RIDGE PORT NORTH 2ND ADDITION

RE: S/D 99-59 — One-Step Final Plat of RIDGE PORT NORTH SECOND ADDITION

STAFF REPORT
(One-Step Final Plat Approved 9/09/99)

CASE NUMBER: S/D 99-59 - RIDGE PORT NORTH 2nd ADDITION

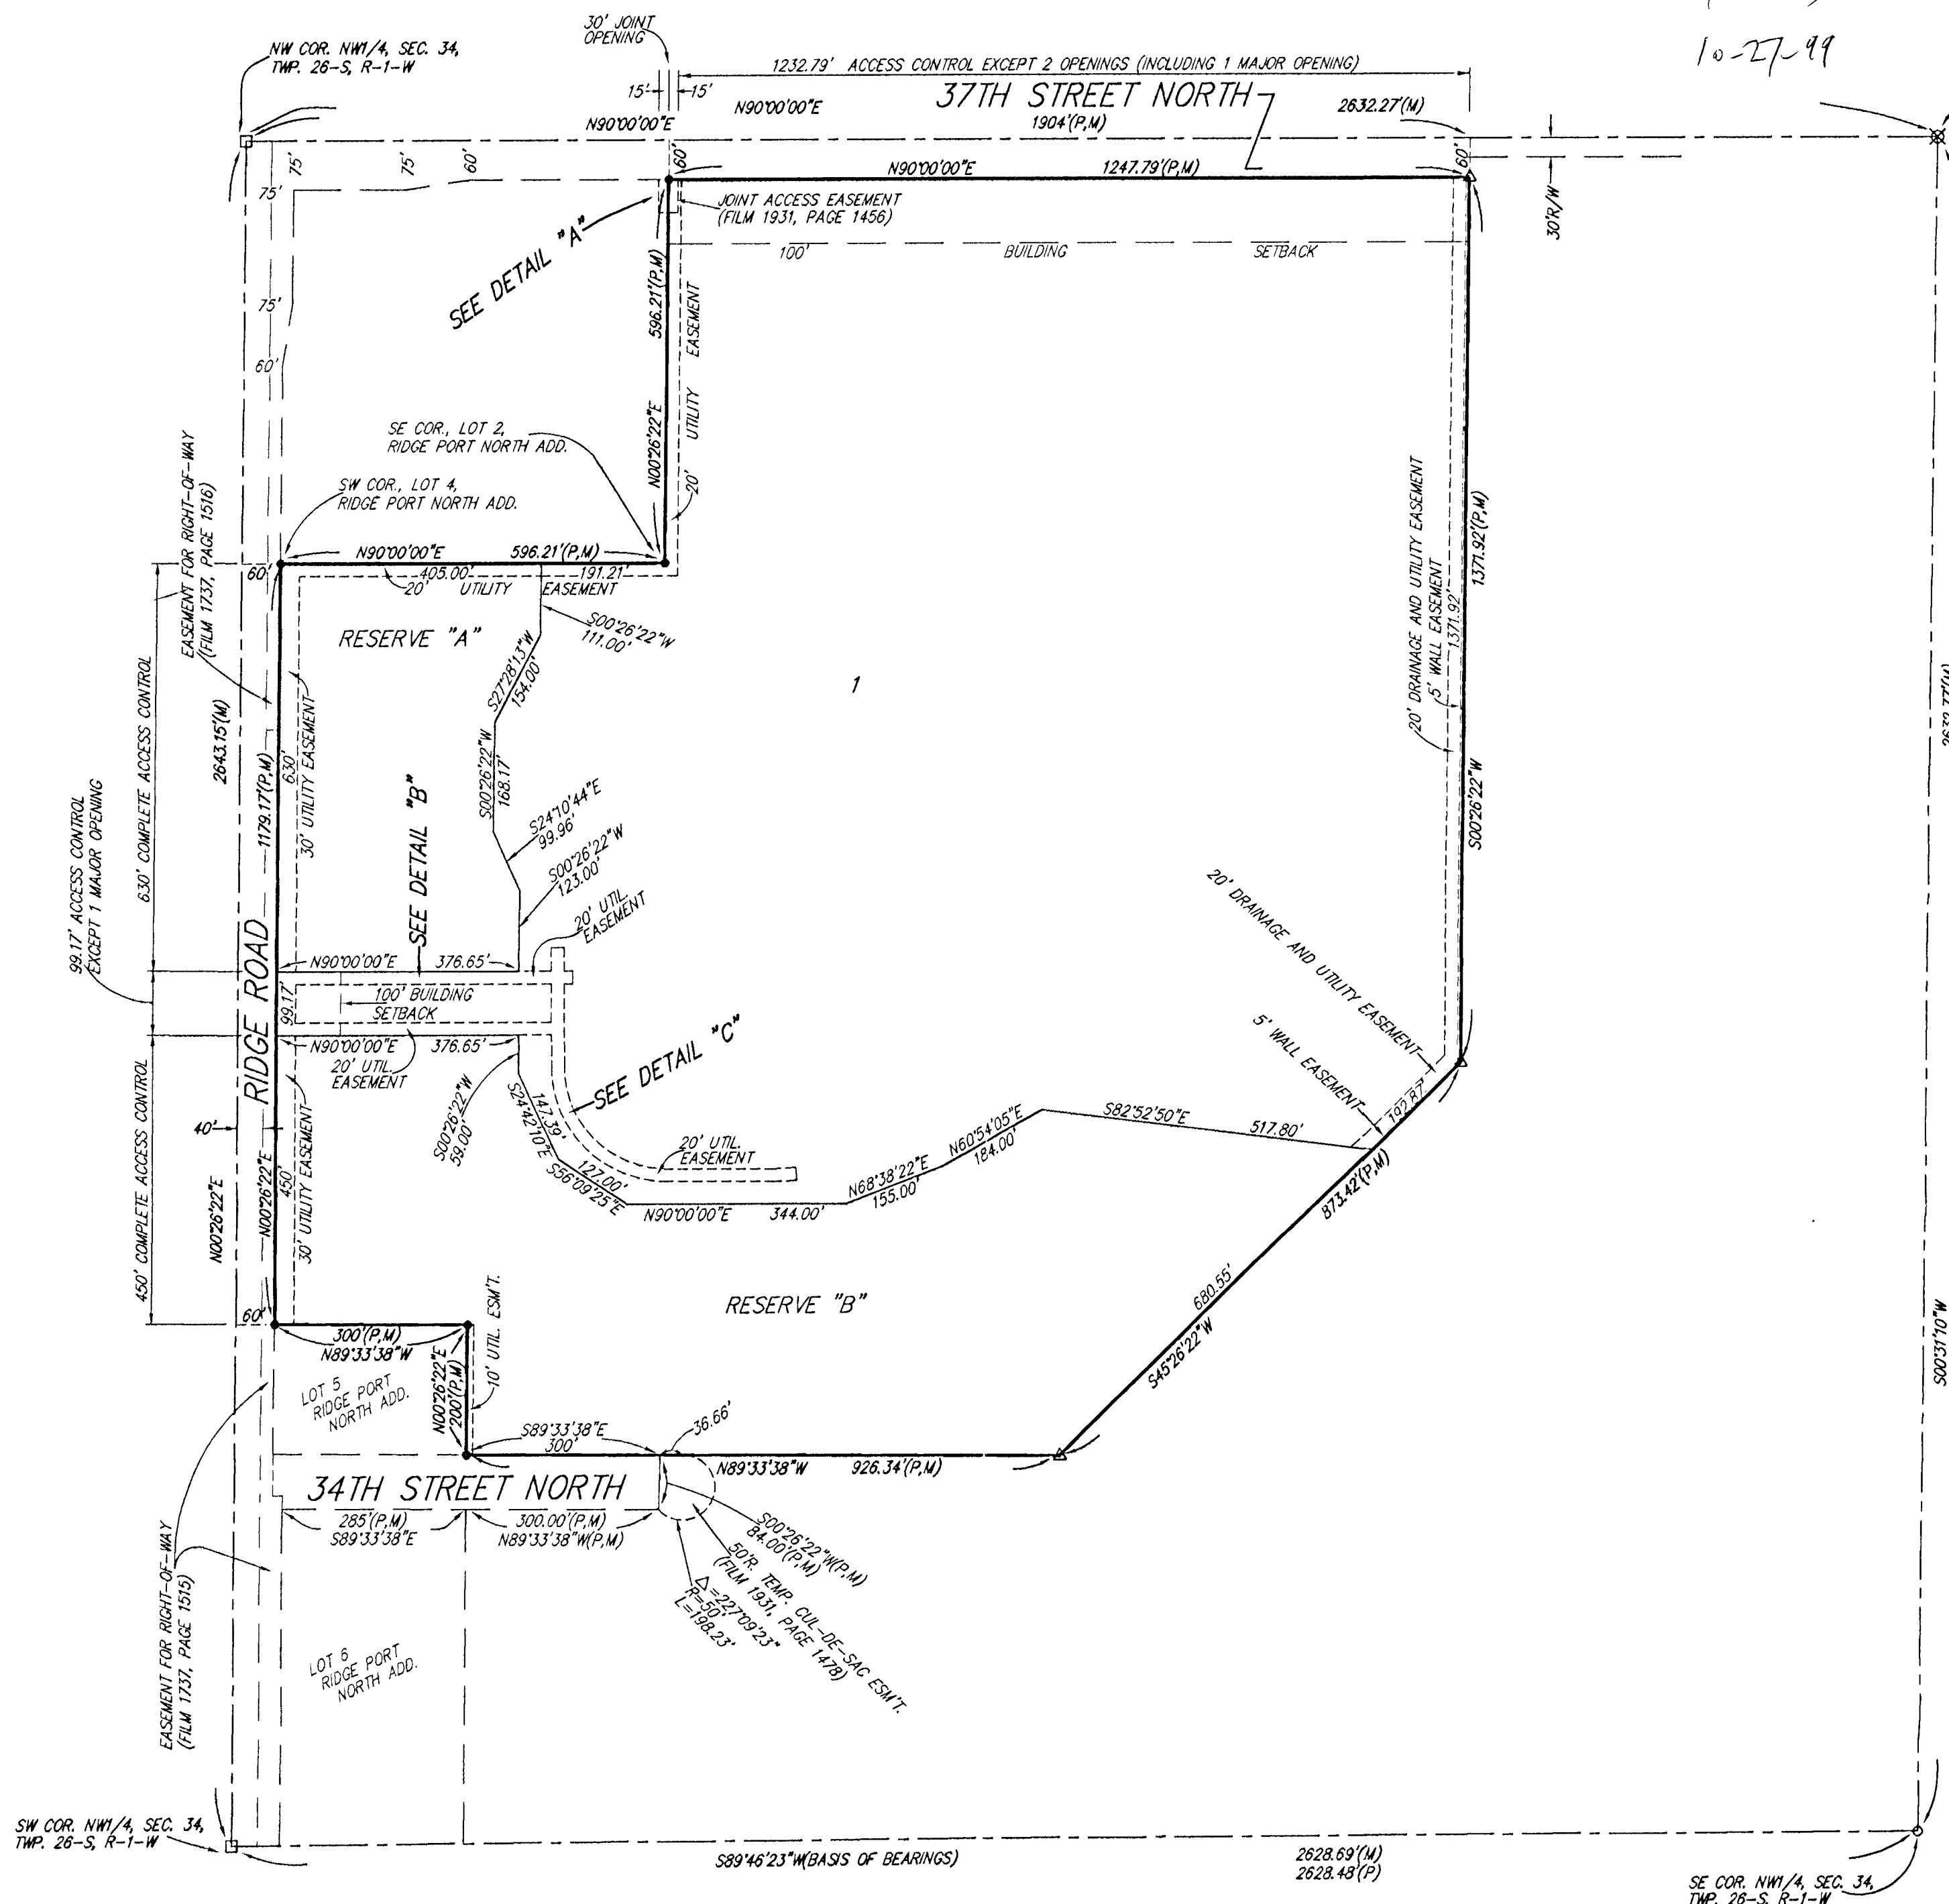
- D. City Engineering needs to comment on the status of the applicant's drainage plan and the accuracy of the minimum building pad elevation. The minimum building elevation shall also be denoted in NGVD. City Engineering needs to comment on the need for a revised petition for the drainage improvements. The drainage plan is approved.

- G. Traffic Engineering shall comment on the access openings. The access openings correspond with those approved for the CUP and Ridgeport North Addition. Two openings have been platted along 37th St. North – one joint opening with the property to the west, and one major opening. The platted access controls indicate two openings along Ridge Road, although the drawing only denotes one proposed opening. The plat shall be revised to denote access control except for one major opening along Ridge Road and a corresponding CUP adjustment shall be filed.

- L. The surveyor's certification shall be revised by referencing "a replat of Lot 1, Ridge Port North Addition".
- M. The recording information shall be denoted for the existing joint access opening between this plat and the lot to the west along 37th Street North.
